<b>Title - Sujet</b> Air Handler/Manifold Replacement	
<b>Solicitation No. - N° de l'invitation</b> 39903-180402/A	<b>Amendment No. - N° modif.</b> 004
<b>Client Reference No. - N° de référence du client</b> 39903-180402	<b>Date</b> 2017-10-05
<b>GETS Reference No. - N° de référence de SEAG</b> PW-\$PWY-025-8166	
<b>File No. - N° de dossier</b> PWY-7-40174 (025)	<b>CCC No./N° CCC - FMS No./N° VME</b>
<b>Solicitation Closes - L'invitation prend fin</b> <b>at - à 02:00 PM</b> <b>on - le 2017-10-17</b>	
<b>F.O.B. - F.A.B.</b> <b>Plant-Usine:</b> <input type="checkbox"/> <b>Destination:</b> <input checked="" type="checkbox"/> <b>Other-Autre:</b> <input type="checkbox"/>	
<b>Address Enquiries to: - Adresser toutes questions à:</b> Fung, Donna(PWY)	<b>Buyer Id - Id de l'acheteur</b> pwy025
<b>Telephone No. - N° de téléphone</b> (604) 671-9689 ( )	<b>FAX No. - N° de FAX</b> (604) 775-6633
<b>Destination - of Goods, Services, and Construction:</b> <b>Destination - des biens, services et construction:</b> CFIA - Burnaby Lab - Burnaby, BC

## ADDENDUM #3

CANADIAN FOOD INSPECTION AGENCY  
AHU REPLACEMENT/EXHAUST MANIFOLD  
BURBABY BC  
Project No: R.39903-180402

**PARTIAL A04 - CRAWL SPACE  
NEW PLAN**

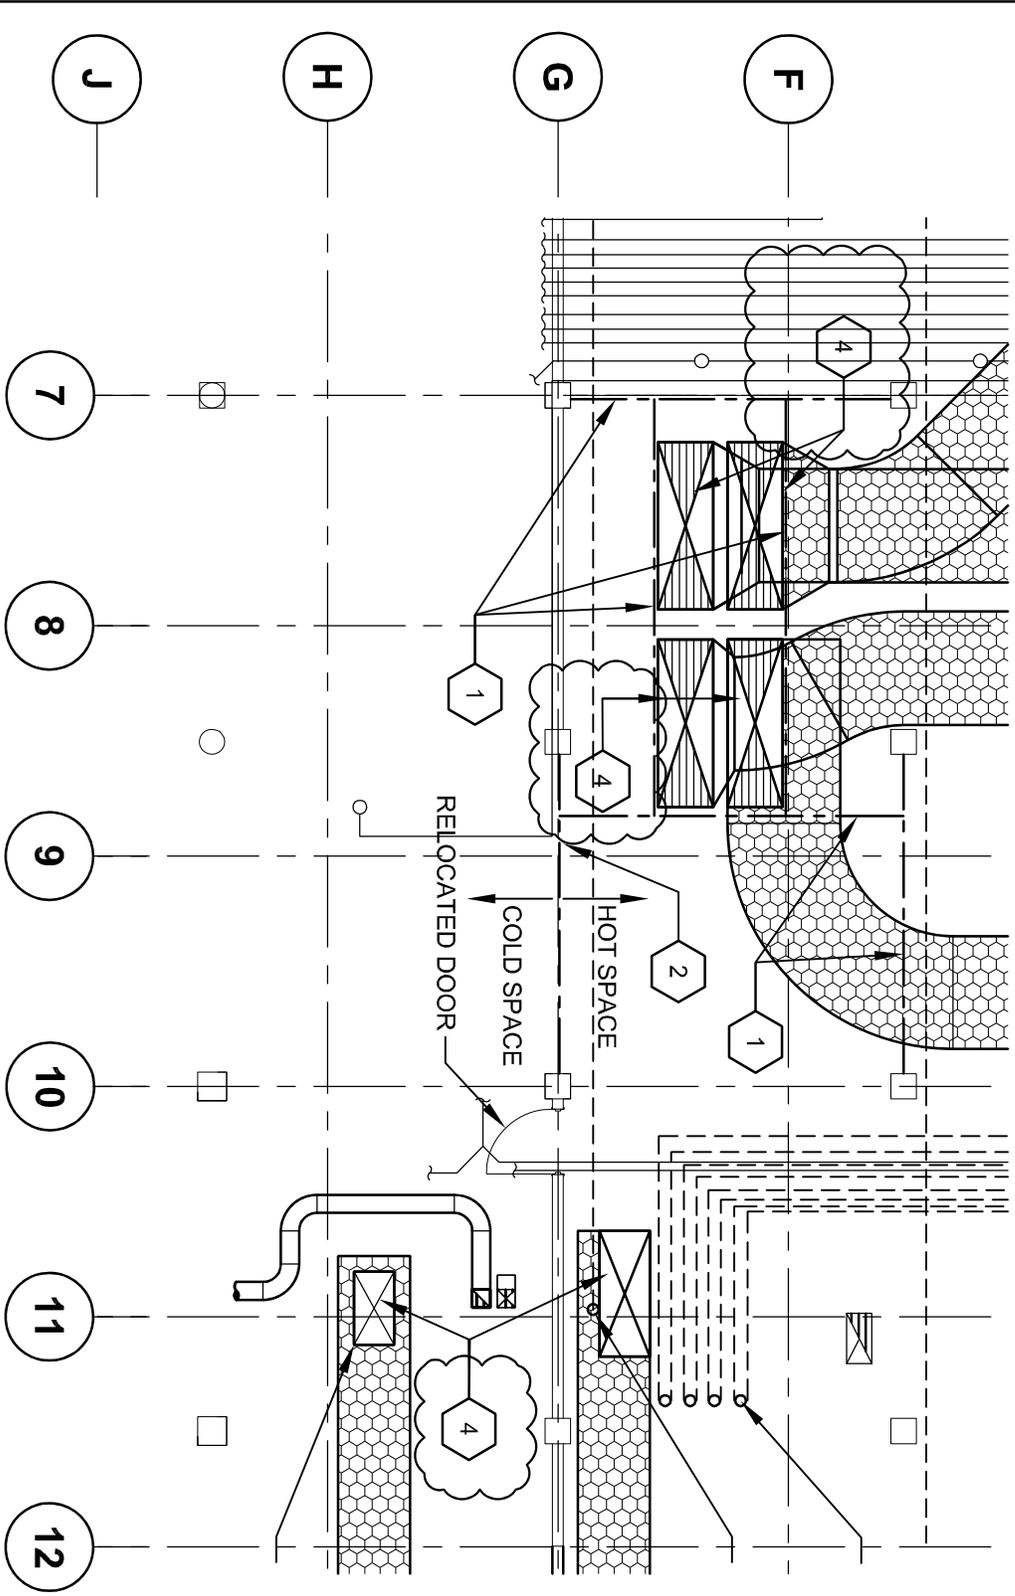
1. Revise PARTIAL A04 – CRAWL SPACE NEW PLAN as per attached AD-01.
